December 23, 2005, 2005

Re: Napaskiak Flooring, 20093.00

Napaskiak water
plant

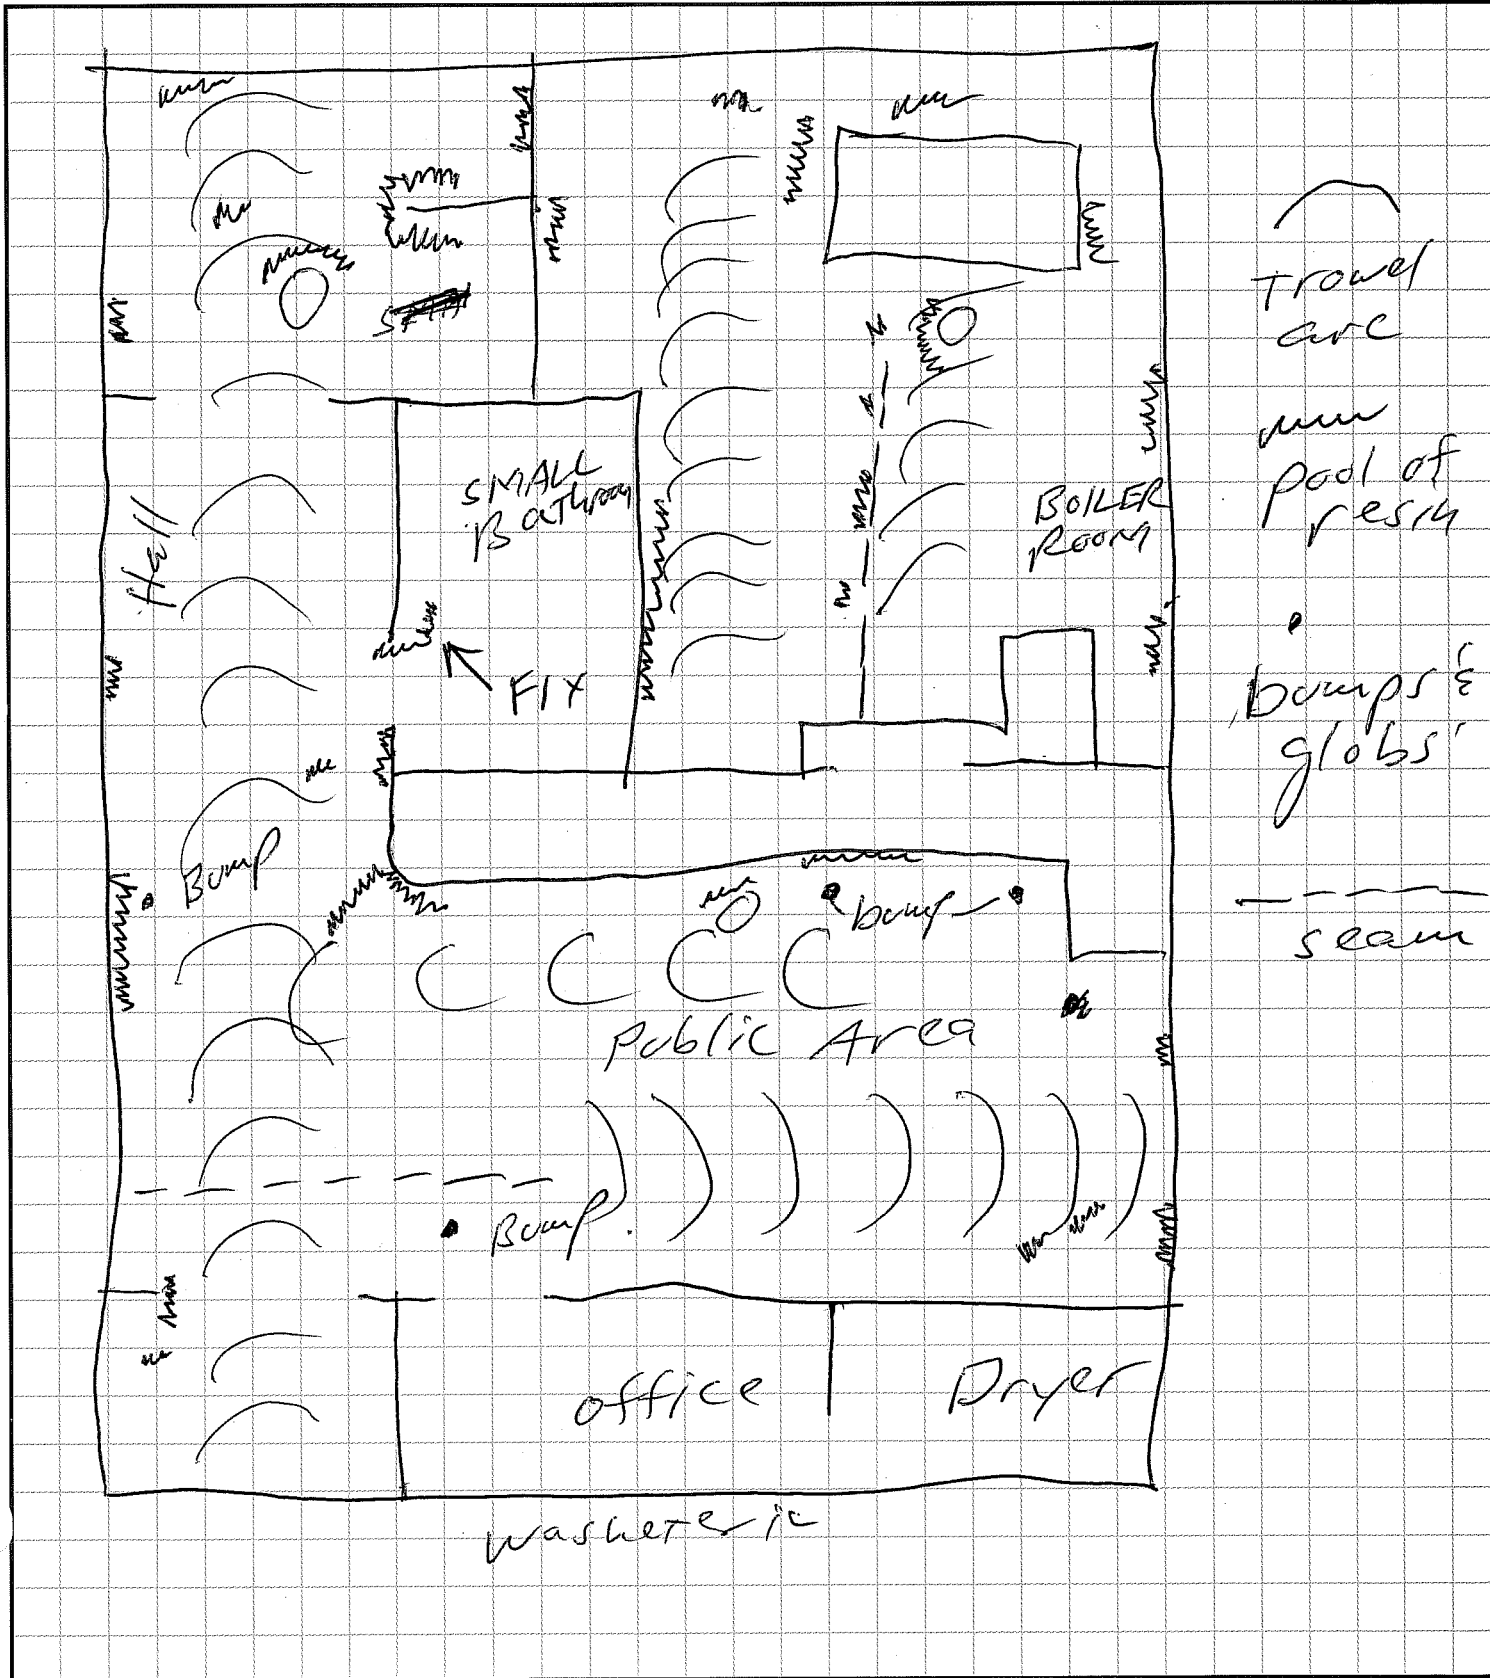
In addition to the trowel marks there are many "pools" of finish resin without aggregate at the surface. There are also scattered protrusions (bumps) and globs of resin on the floor (see attached sketch).

Pool
old & missing
wall

Globs

Please return and make the flooring look uniform. All areas need repairs except the office, dryer room and small bathroom. We would like this done prior to January 14, 2006 if possible since the work crew returns then. We will not pay your invoice until we have a satisfactory product.
